DraftPreliminaryHRSC_CSM_FID_082416_TowerStandard.4dm - 4DIM Player
Author: Jason C. Ruf
Organization: S2C2 Inc.
Description: Draft CSM for High Resoluti...
Tower Standard Site
Lac du Flambeau, Wisconsin
Data Analysis and Data Visualization Report
August 2016
Vertical Exaggeration is 2.5x
MIP-FID above 50,000 uV
S2 C2 inc.
MIP-FID
10,000,000 uV
3,000,000 uV
1,000,000 uV
300,000 uV
100,000 uV
30,000 uV
10,000 uV
Total VOCs
1,000,000 ug/kg
300,000 ug/kg
100,000 ug/kg
30,000 ug/kg
10,000 ug/kg
3,000 ug/kg
1,000 ug/kg
300 ug/kg
100 ug/kg
30 ug/kg
10 ug/kg
3 ug/kg
1 ug/kg
2D Maximum Plume
1,990,400
1,990,500
1,990,600
1,990,700
Easting
NOTES:
See Data Analysis and Data Visualization Report for data visualization details.
Inbox - Mailbox - Kady, Tom - Outlook
To... Egan, Robert
Subject: RE: Recommendations for additional well locations at the Tower Standard site
Hi Bob – I've included below in red some of the logic and additional details from our discussion on the proposed monitoring well locations. I believe this information will help to provide some boundary conditions to improve the accuracy of the 3D data visualization and to help provide a reliable basis to quantify the mass distrib

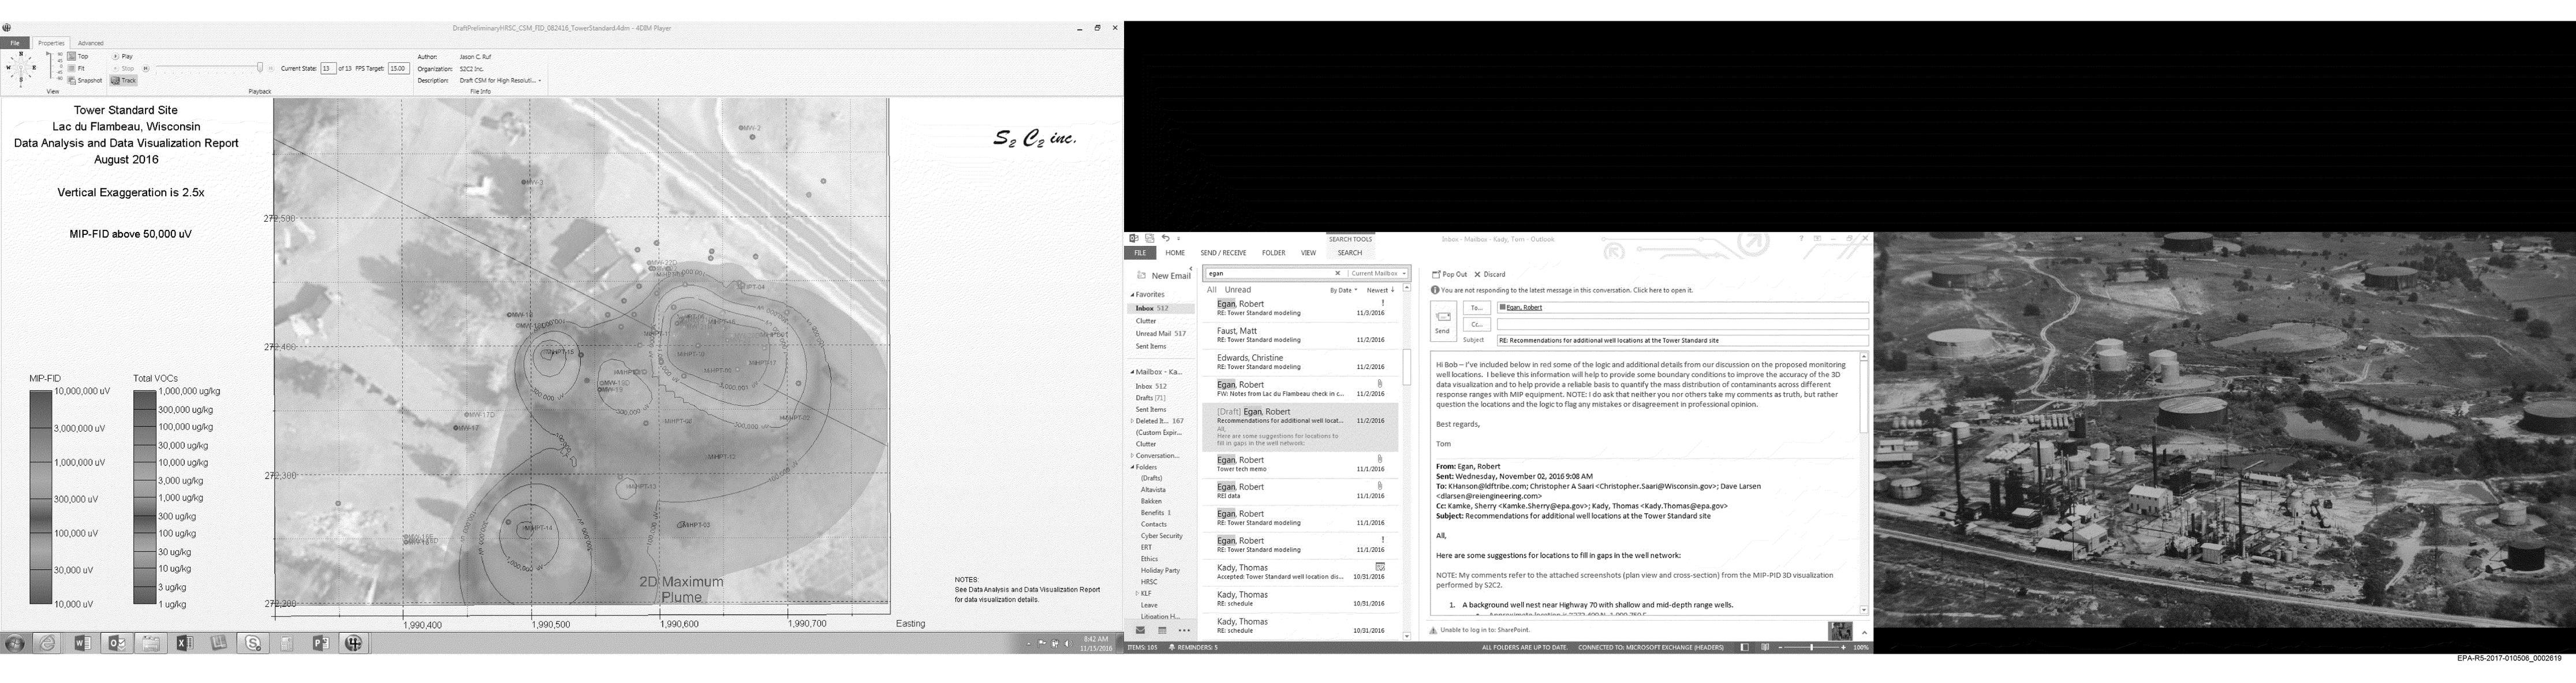
1. A background well nest near Highway 70 with shallow and mid-depth range wells.
Unable to log in to: SharePoint.
8:42 AM
11/15/2016
